From: KarenD Hadden <karendhadden@gmail.com>
Sent: Monday, July 30, 2018 11:20 PM
To: HOLTEC-CISEIS@nrc.gov; Holtec-CISFEIS Resource
Subject: [External_Sender] Public Citizen and SEED Coalition Comments on HOLTEC-CIS Application
Attachments: Holtec Comments Final 7-30-18.docx

**Holtec's Radioactive Roulette:
Why High Level Radioactive Waste Should Not Be Stored in New Mexico**

**Ref: USNRC Docket No. 72-1051
THE PROPOSED HI-STORE CIS FACILITY
July 30, 2018**

Figure 65.1 New Mexico State Rail System in 2014

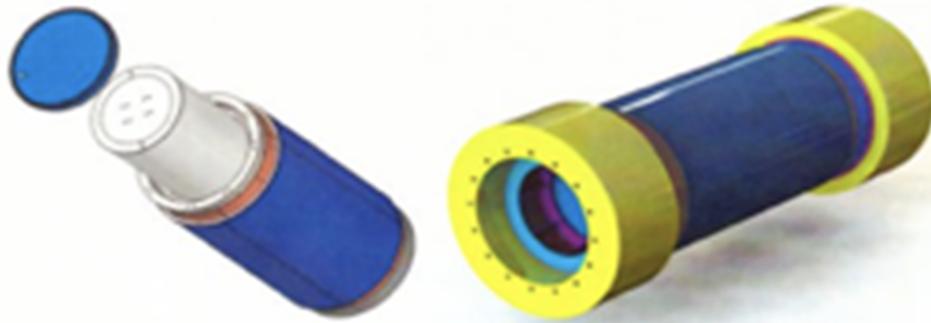
The rail lines that would carry radioactive waste would run right along the edge and potentially over a mined out section of the Carlsbad sinkhole. Overweight radioactive waste trains alongside a sinkhole create a recipe for disaster. John Heaton, Holtec’s spokesman, says that this concern is unfounded because the rail lines run to the north of Carlsbad, but Holtec’s

application (page 157) and the above New Mexico State Rail map shows that line running along Highway 285 and then east along 62 to the Holtec site.

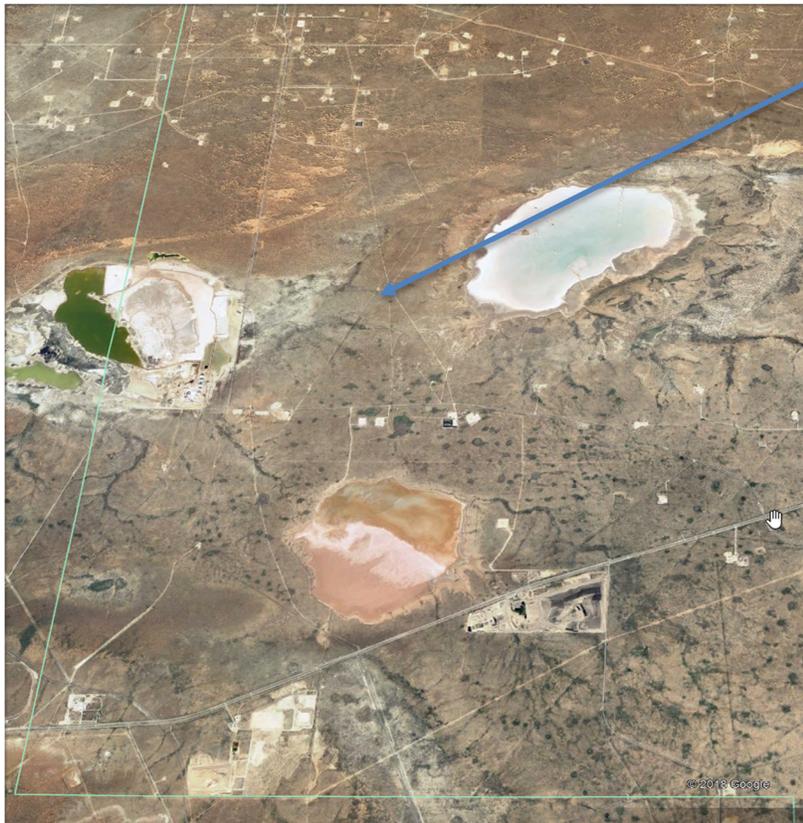
playa lakes. (Holtec pg 179) Given the location of the proposed site relative to the playa lakes and the presence of groundwater at 35' to 50' below the surface, isn't it probable that water will leak into the site?

"The way it's built is they excavate down 30 feet and then they put a 3 foot layer of reinforced concrete on the bottom of the excavation.," Heaton said.²³

Another 3-foot layer of reinforced concrete is added near the top of the silo so it is resistant to airplane crashes and rockets. The applications does not contain an adequate plan to is there not an adequate plan for remove the water from a canister?

If there are no drains in Holtec's canisters how will water be removed? Shouldn't the plans include a drainage system? At recent legislative hearings the possibility of using the waste heat at the storage site to purify brackish water was been raised.
